Subject: **COLUMBIA GENERATING STATION, DOCKET NO. 50-397
ENERGY NORTHWEST'S THIRD SIX-MONTH STATUS UPDATE
REPORT FOR THE IMPLEMENTATION OF NRC ORDER EA-12-049
MITIGATION STRATEGIES FOR BEYOND DESIGN BASIS EXTERNAL
EVENTS**

**THIRD SIX-MONTH STATUS UPDATE REPORT FOR THE
OVERALL INTEGRATED PLAN FOR MITIGATION STRATEGIES FOR BEYOND
DESIGN BASIS EXTERNAL EVENTS AND ATTACHMENTS**

Revised Conceptual Sketches

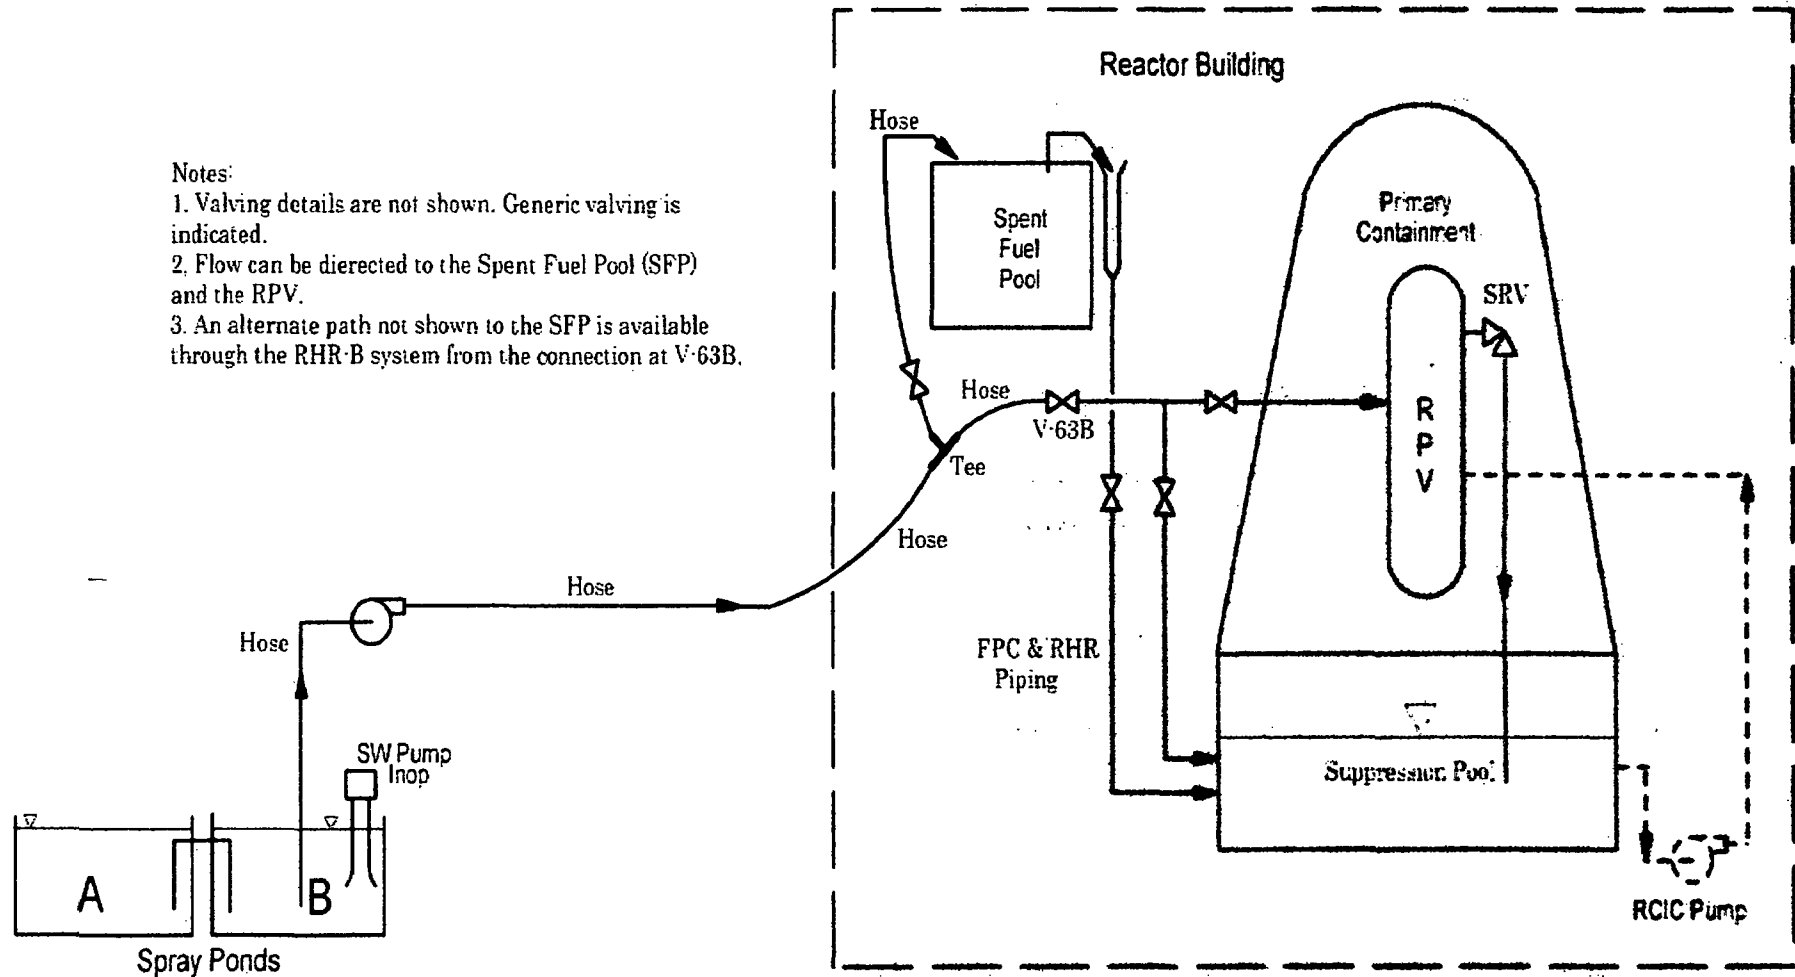
Cooling water will be supplied from the Standby Service Water (SW) system spray ponds to the SFP using one of the high head portable pumps (Godwin pump or pumper truck) and fire hoses. While cooling water is supplied to the SFP, the overflow will cascade down the Fuel Pool Cooling (FPC) and Residual Heat Removal (RHR) piping to the suppression pool as shown in Sketch 3, "Phase 2 Makeup Flow Diagram." This flow mitigates the temperature rise of the suppression pool and provides a means of suppression pool makeup. During the assumed three-day ELAP, with the 300 gpm makeup, the suppression pool level does not increase to the wetwell vent outlet level.

As shown in Sketch 3, makeup water can also be supplied to the RPV at the same time SFP cooling water is provided. RPV makeup, by this means, provides a backup source in case RCIC were to fail. Analyses show that the high head pumps can provide 300 gpm to the SFP while meeting the RPV makeup water requirements.

Implementation of the makeup function involves connecting hoses from the pump located near the spray ponds, across the yard area, and up the RB northeast stairwell (preferred path) or southeast stairwell (alternate path). In the RB, the hose will be connected to a tee with one discharge path supplying the SFP and the other supplying the RHR piping at valve RHR-V-63B (preferred) or RHR-V-63A (alternate). The RHR supply will be able to provide makeup water to the suppression pool and/or the RPV. These valves will be manually aligned as necessary to direct the flow.

Sketch 4 – Phase 3 Service Water Flow Diagram

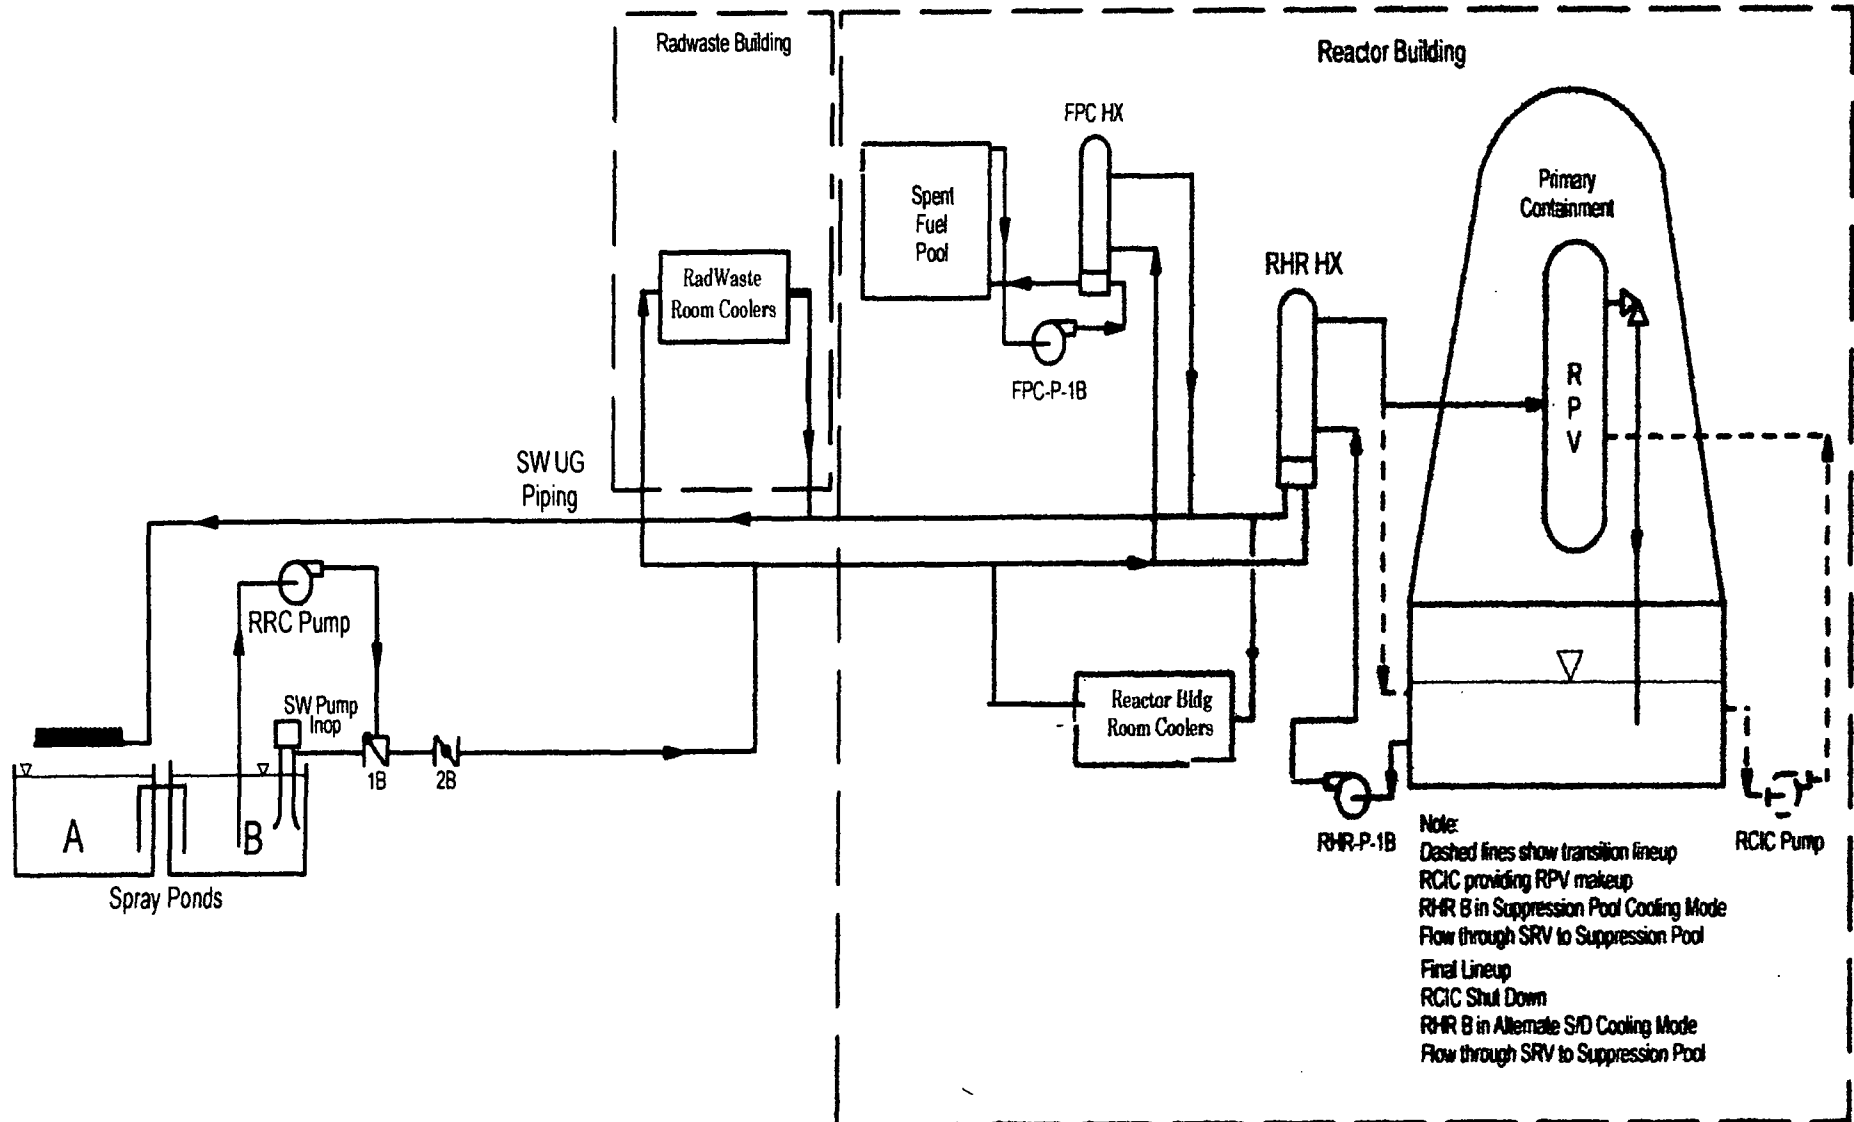
In Phase 3, equipment from the Regional Response Center (RRC) will be available to transition the plant from the Phase 2, use of portable pumps available on site, to the alternate shutdown cooling alignment shown in Sketch 4, "Phase 3 Service Water Flow Diagram." In this alignment, an RHR pump takes suction from the suppression pool and supplies water through the RHR heat exchanger, then to the RPV for makeup. The water from the RPV flows through an SRV back to the suppression pool. The dashed lines in Sketch 4 show the transition lineup, in which RCIC continues to run while the RHR system is lined up for suppression pool cooling. Once flows are stabilized and suppression pool and RPV temperatures reduced to the point that RCIC is no longer desired, the return to the suppression pool would be redirected to the RPV, and RCIC shut down.

The standby SW system piping provides the pathway for cooling the RHR heat exchanger and the FPC heat exchanger. An RRC pump takes suction from a SW spray pond and provides approximately 5000 gpm to the SW piping at the SW pump discharge check valve. A special adapter designed to enable the connection of the RRC pump discharge (via hoses) is connected to the bonnet of the discharge check valve. Flow can then be established in the normal direction in the SW piping. The cooling water flow established in the SW piping also provides cooling to room coolers in the reactor and radwaste buildings. Cooling water is returned to the SW spray pond's oriented spray cooling system (OSCS) for heat dissipation to the atmosphere.

Analyses indicate that the OSCS associated with the spray ponds can provide sufficient heat transfer to provide cooling water at less than 85 degrees Fahrenheit with the lower flow rate of the RRC pump (~5000 gpm vs ~10000 gpm normally) if half of the spray nozzles are plugged. Since the RRC equipment is not expected to arrive until at least 24 hours after the loss of AC power, there is sufficient time and staff to install the SW adapter at the discharge check valve, install the OSCS nozzle plugs, and valve out SW flow to the unavailable station emergency diesel generators.
